U.S.S.N. 09/700,139
Group Art Unit: 2644

AMENDMENTS TO THE DRAWINGS

Fig. 4b

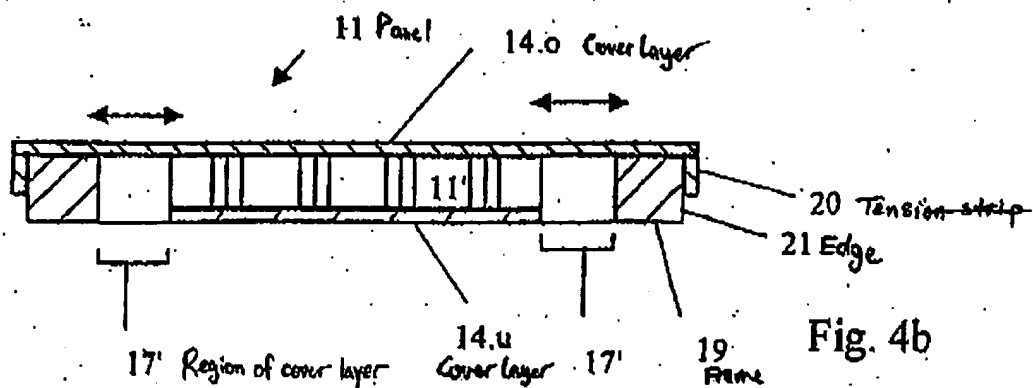
Figs. 4b and 5b are amended to indicate that reference number 17' refers to "Region of cover layer" rather than to "connecting element." Support for this amendment may be found, among other places, at page 8, line 11 and line 24 of the specification as filed.
